**KNOXVILLE HISTORIC ZONING COMMISSION
STAFF REPORT - CERTIFICATE OF APPROPRIATENESS APPLICATION**

PROPERTY ADDRESS: 1424 Fremont Ave

FILE NO.: 6-F-17-HZ

LEVEL OF WORK: Level II. Major repair or replacement of materials and construction of addition

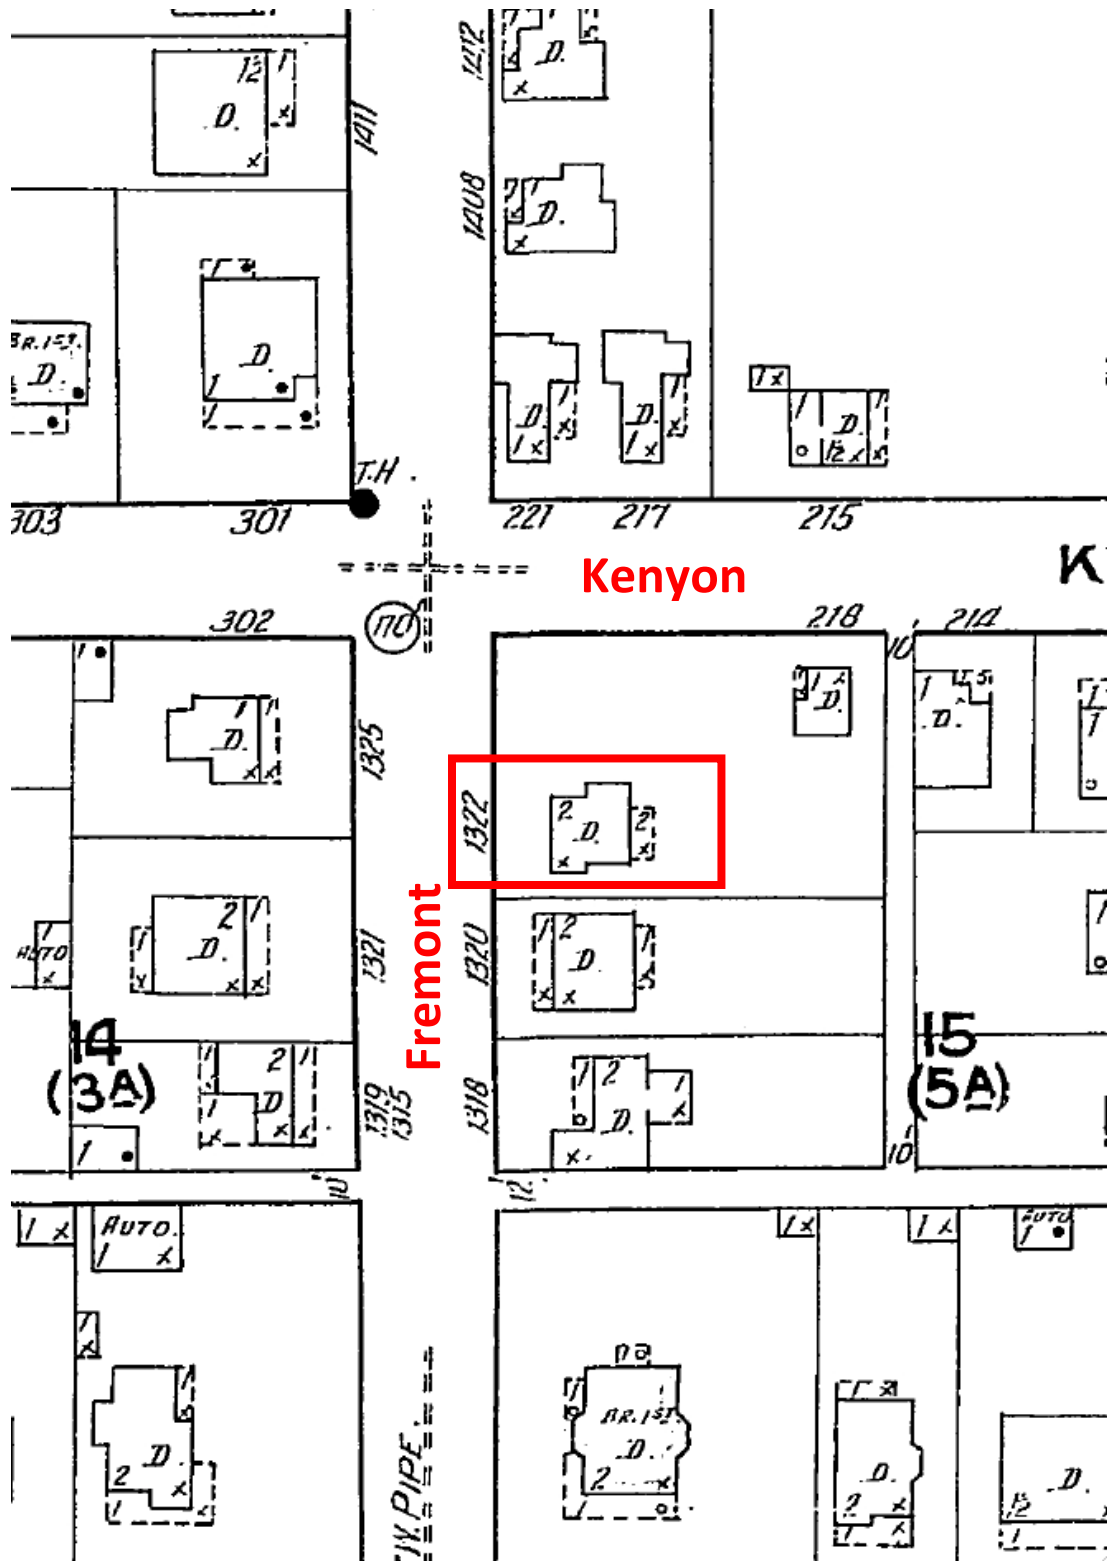
4) Non-original side door removal, opening to be replaced with siding.

Facing the street, on the left side of the house, is an awkward non-original door. Typically a side door like this would be seen on a wraparound porch, but in that case the porch roof would traverse over the slightly lower staircase window (original). Further, the 1917 Sanborn maps do not show a wraparound porch on the property (the house numbers on the street have changed and the map lists the property as 1322 Fremont Place). Finally, there is no shadow of a foundation that would support a wraparound porch. We would like to remove this non-original door and replace with siding.

A wrap around porch (which would support a side door) would have traversed the lower staircase window.

Cinderblock foundations to the makeshift landing also supports that there was never a wraparound porch.

A wrap-around porch (which would support the existence of a side door) would have inappropriately overlapped the window on that side. Further, the 1917 Sanborn maps do not show a wrap-around porch and there is no shadow of a foundation that would have supported a porch on that side.

- 1) A double-hung wood replacement window may be installed on the front second level as shown in the submitted drawing/photo if internal demolition indicates that a window originally existed in that location;
- 2) Replace windows in-kind on a case-by-case basis if their condition is found to be such that repair is not feasible -- as approved by staff ;
- 3) Replace the front door with a wood door with a 2/3 or 3/4 unembellished beveled glass panel and sidelights with dimensions as indicated by original framing -- as approved by staff and;
- 4) Install two wood double-hung windows on each side of the addition that match the typical size of the larger historic windows on the house.

Current addition

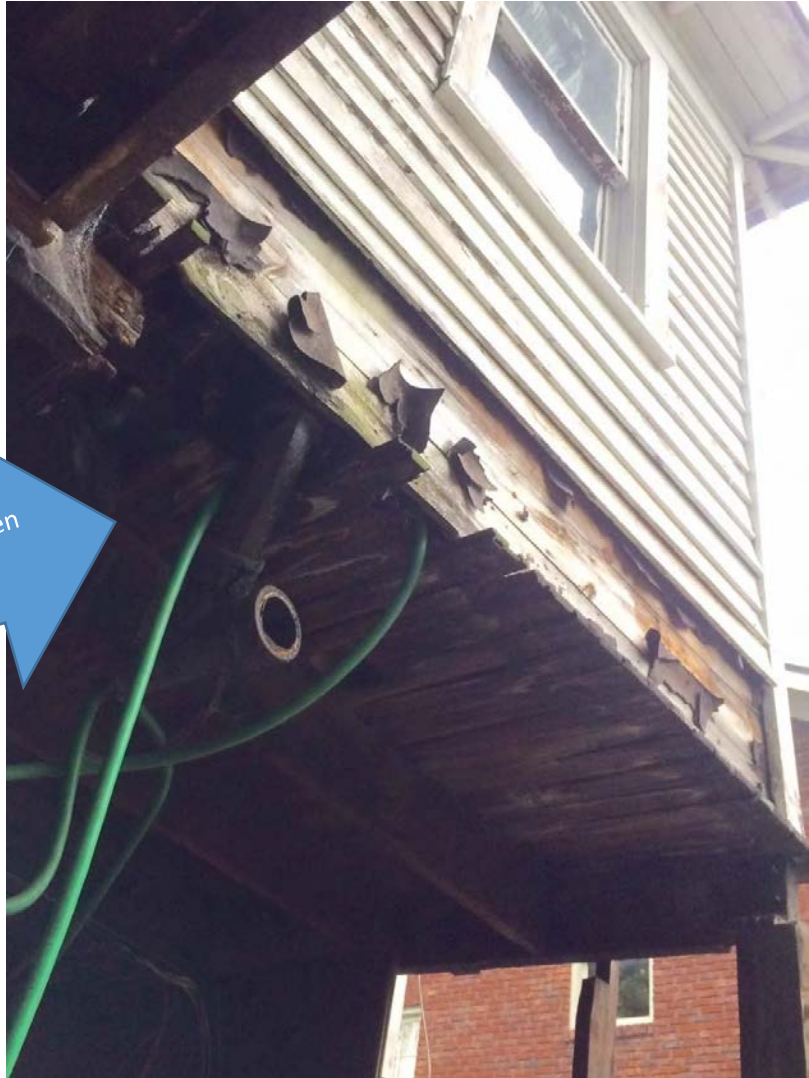
The rotting floor and supports have caused the addition to pull away from the house.

The current addition cannot be seen from the road.

6) The 1917 Sanborn map footprint indicates the 6'x7' rear frame addition is not original. Its structure is pulling away from the main house. Joists are missing, and the vertical supports have rotted, so it is not feasible to repair.

Proposed First Floor

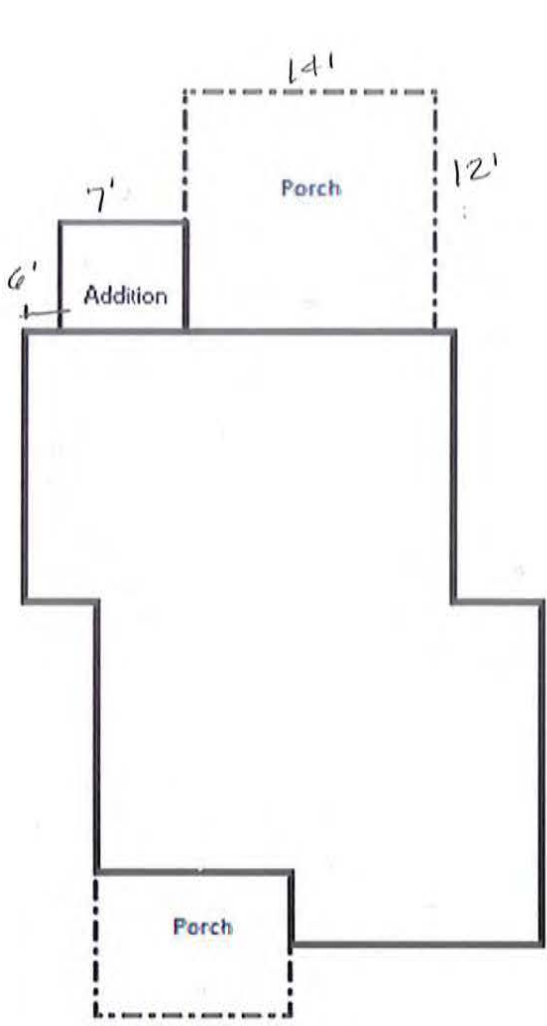
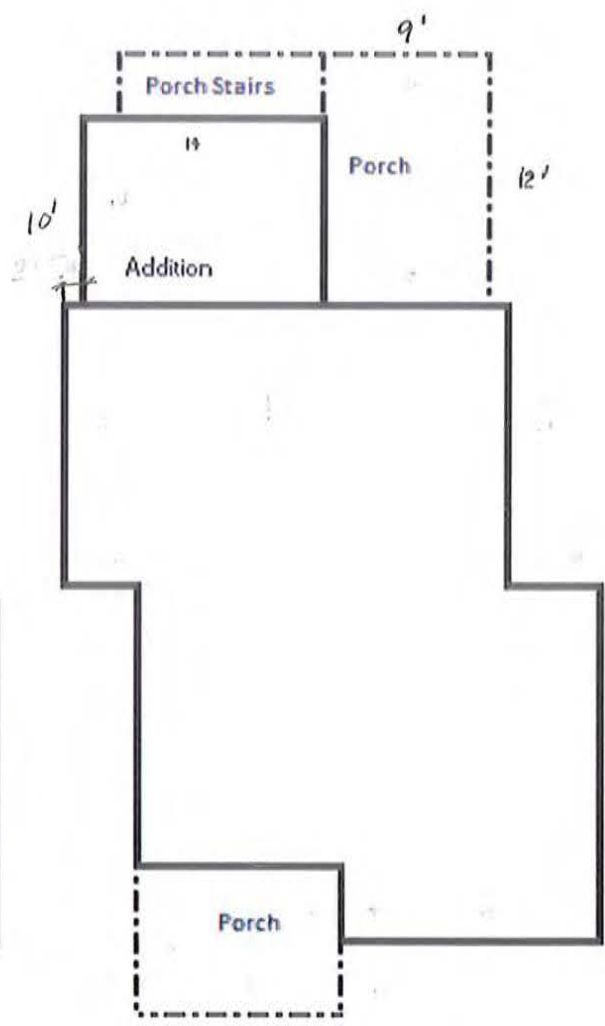
5) Rear addition replacement with a slightly larger footprint.

The current rear addition, which houses the only bathroom on the first floor, is pulling away from the house in addition to being fundamentally unstable. We would like to remove this 6'x7' addition and replace it with a slightly larger addition of 10'x14'. As we can see in the Sanborn map above (page 12) this addition is not original. Due to the small footprint of the house there is not any additional space on the first floor where we could locate a bathroom.

The addition will extend 10' and will have two windows the same size as the double kitchen windows (26"W x 43"H). These will be centered on the wood siding.

The foundation for the addition will be stucco with wood siding up to the first level where a belt course will be installed.

4) The proposed rear addition replacement will not be easily visible from the right-of-way, with only slightly more in view than is the currently existing addition. The addition will be offset from the northeast corner of the house by approximately 12-18 inches and the design is proposed to be similar to the existing.

5) The existing addition was not well-constructed/designed, so it has not acquired historic significance in its own right.

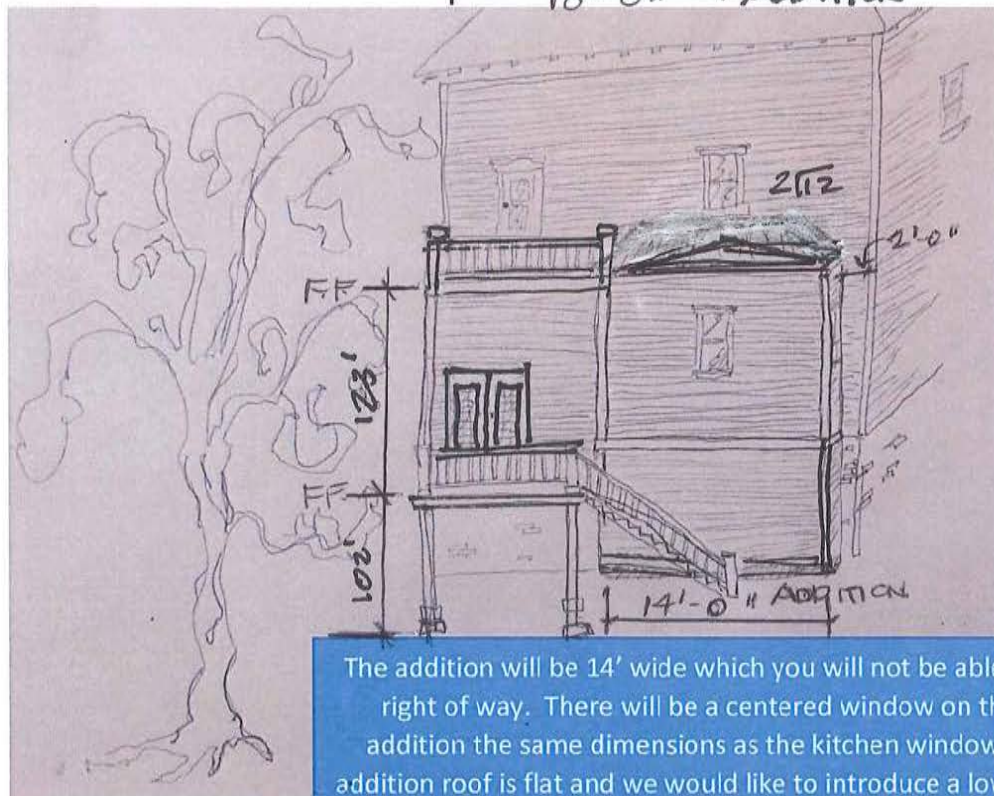
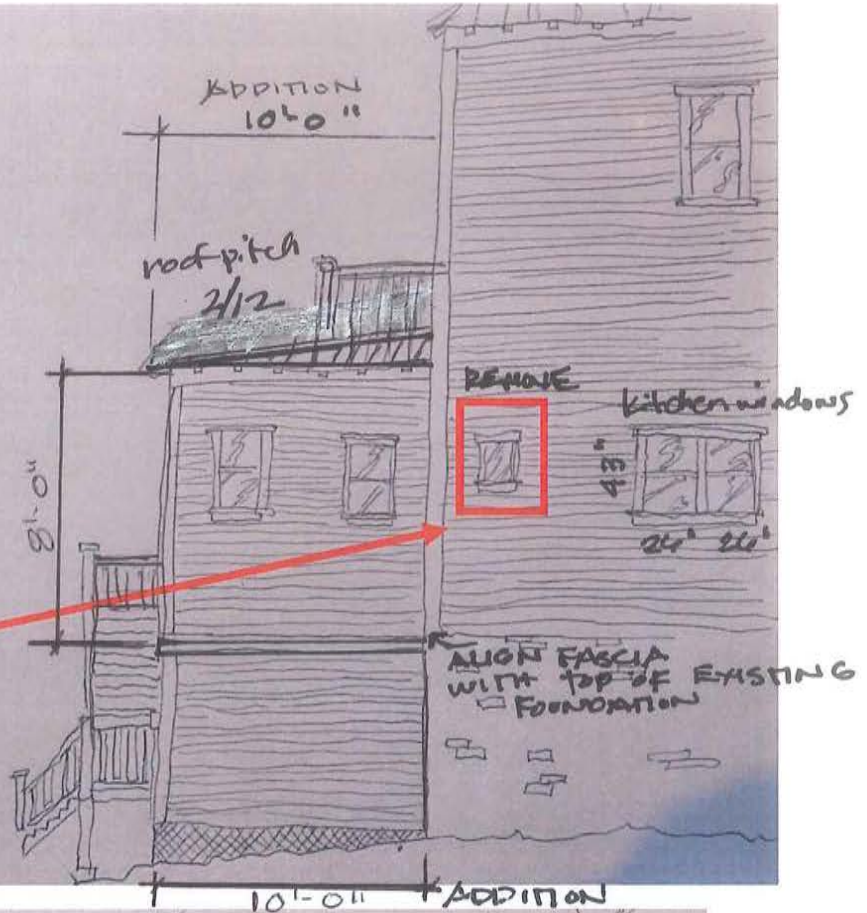
We are proposing the removal of the small portal casement window in the drawing.

The addition will be 14' wide which you will not be able to see from the right of way. There will be a centered window on the back of the addition the same dimensions as the kitchen windows. The current addition roof is flat and we would like to introduce a low pitch slope roof similar to the body of the house.

9) The small fixed window on the side of house is not properly framed or installed and does not appear original, so its removal will not cause a loss of historic character.

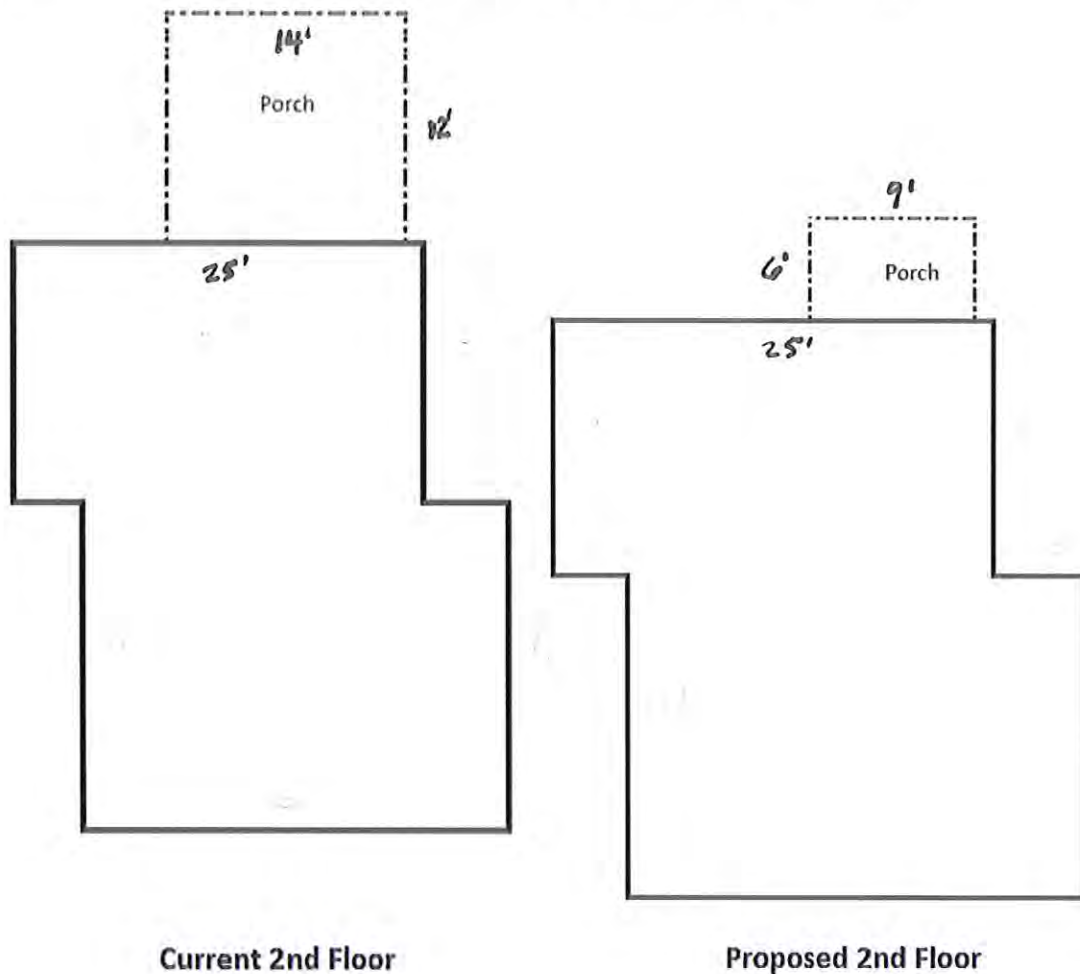
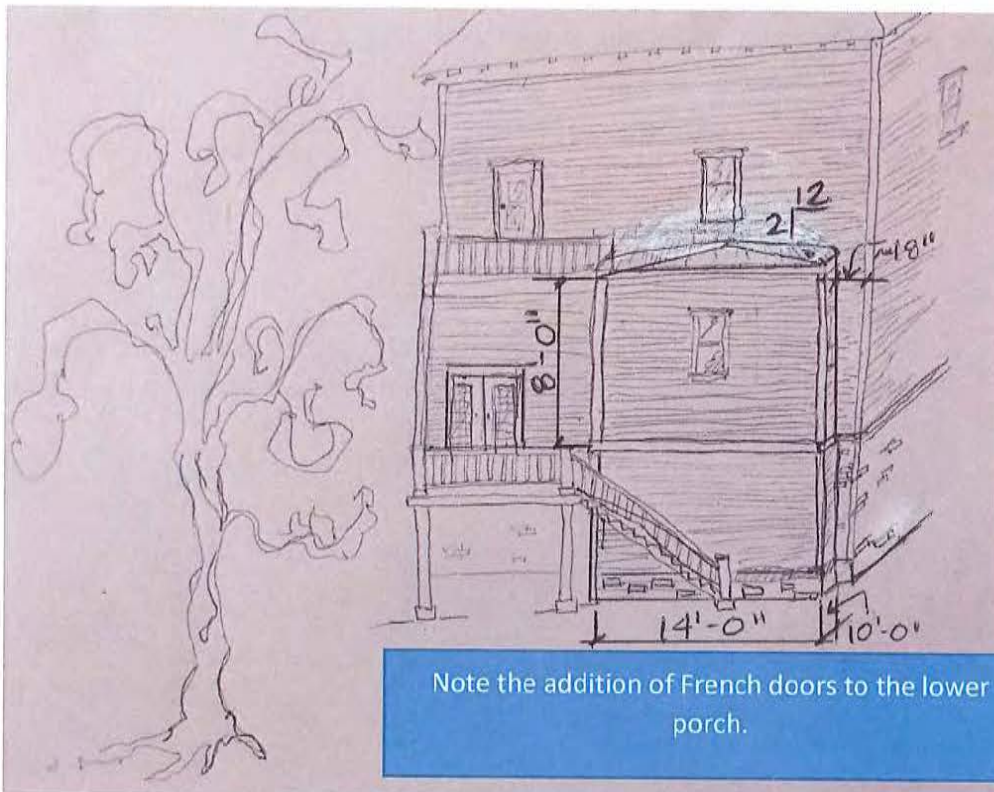
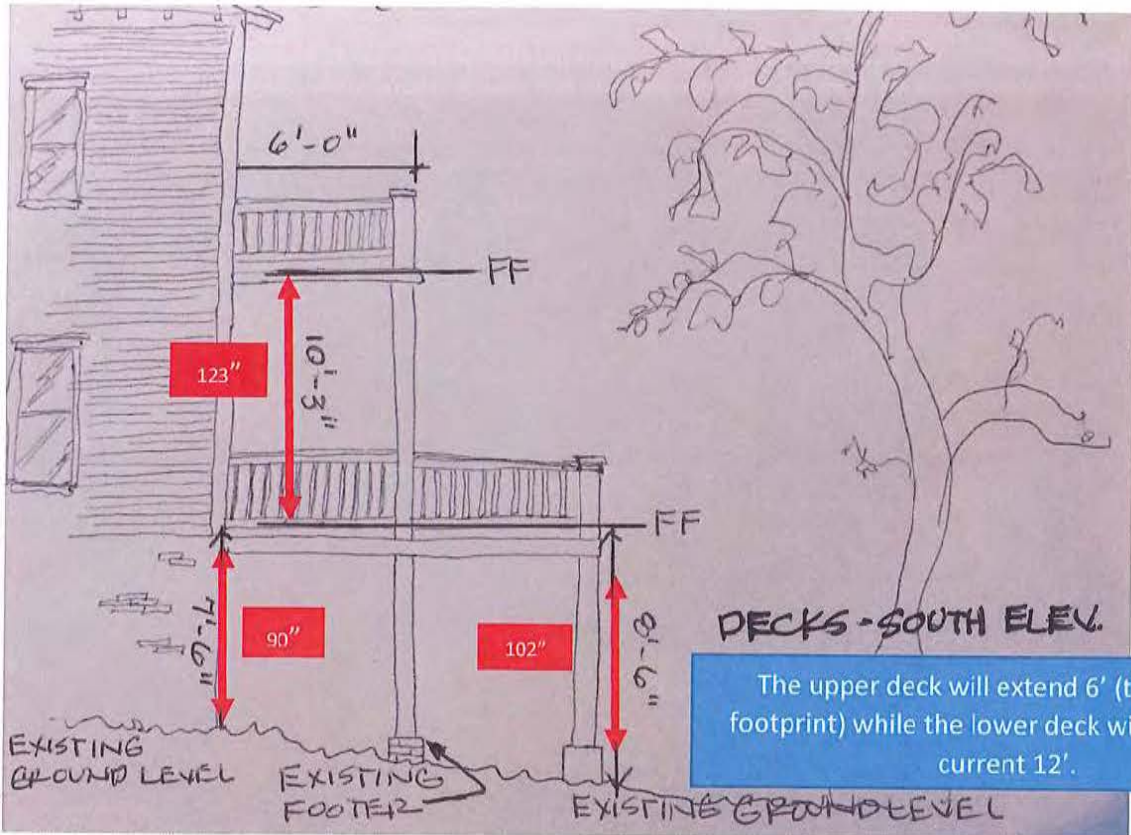
6) Rear porch restoration/interpretation.

Currently there are two 14'x12' non-original covered porches on the rear of the house. Though these do allude to the sleeping porches of the time period the 1917 Sanborn Maps show us that these were much smaller and were not conducive to sleeping porches. Additionally, photos show that the porches were open air (the upper porch roof never tied to an additional porch roof). To respect both the current and historic footprint of the porches we are proposing the upper porch be reduced in size to the original configuration while the lower porch retain its current depth. This is a marriage of both versions of the porches the house has had and the overall visibility would be reduced dramatically. The porch will be composed of wood with square balustrades, similar to the front porch railing, tied to the top and bottom railings (*not* nailed to the exterior).

It is important to note that on the first floor porch we propose the addition of wood French doors to from the house to the porch. This addition would swallow a window that will be used within the proposed addition above. These doors cannot be seen from any right of way.

7) Currently, two 14'x12' non-original decks exist on the rear of the house, with the top one being covered by a shed roof. The 1917 Sanborn Maps indicate there were two tiers of decks, but they were smaller. Additionally, the visible structural elements of the main house roof and the deck roof indicate that the upper porch roof was later tacked-on to the original main house roof, and not properly integrated into the structure. Also, the later-added deck roof does not have exposed rafters as seen on the main house and front porch.

8) The two-tiered rear deck reconstruction will be similar to existing, but will be less obtrusive without the non-original roof covering. It will maintain its current offset from the house corner and will not be visible from the r-o-w.
